THE CITY OF SAN DIEGO

SUBJECT: **ITEM 6 – 1445 GRANADA AVENUE AND 2885 BEECH STREET**

Report to the Historical Resources Board

SUBJECT: **ITEM #9 – 1445 Granada Avenue and 2885 Beech Street**

San Diego Union, October 10, 1920

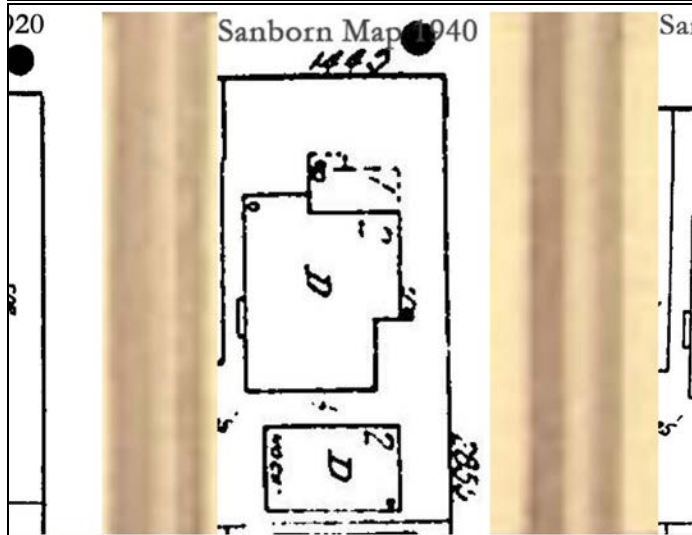
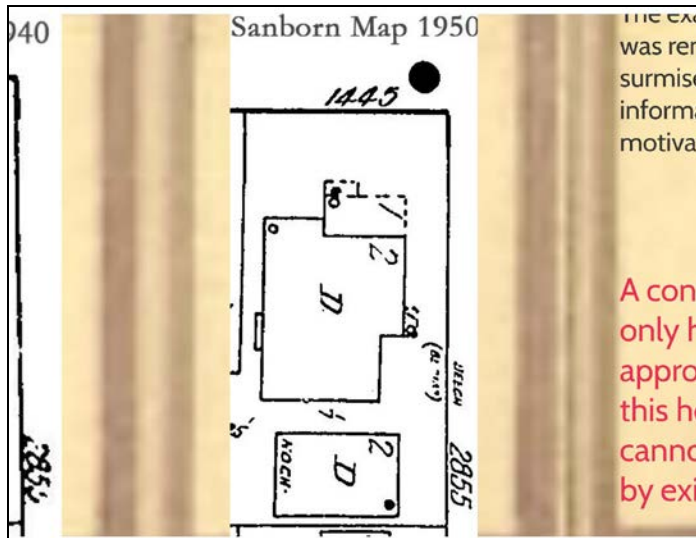
An advertisement in the San Diego Union from 1920 claims the roof was tile acknowledging the common use of “crushed tile” roofing material (i.e. asbestos-cement roofing material)

Sanborn map from 1920 clearly indicates that all roofing surfaces are composition, a category that includes asphalt shingles.

Sanborn map from 1940 indicates a noncombustible roof which includes tile, masonry, metal or asbestos shingle roofs. It does not conclusively indicate a tile roof.

Sanborn map from 1950 clearly indicates all roofing surfaces are composition.

Close up of photograph from 1920 newspaper advertisement.

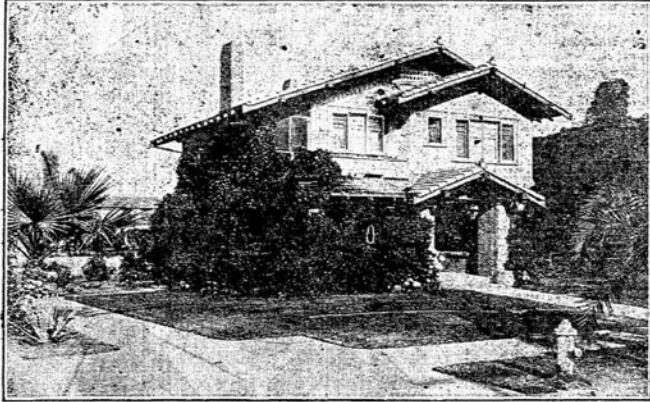
The type, shape, color, and size of the tiles cannot be determined from this picture and are not given in any other documentation.

To replace the existing roof with a 'best guess' tile selection would be conjecture at best and would create a false and inaccurate sense of historicism.

Close up of house at 2124 Sunset Blvd.

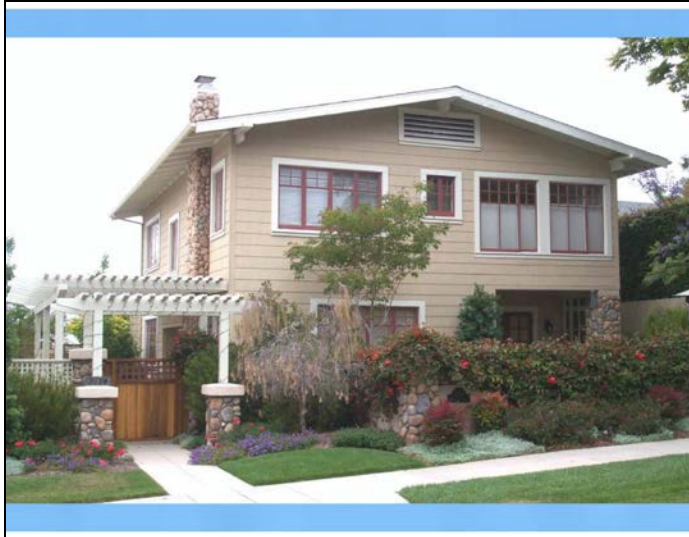
In a similar situation, the only other single family home designed by Joel L. Brown that has been designated was accepted despite the application of rock over the original brick of the chimney because it was appropriate to the style (Drown-Wagenhals-MacDonald House, HRB 593).

Similarly, the only other single family house designed by Joel L. Brown that has been designated was done so despite the application of rock over the original brick chimney.
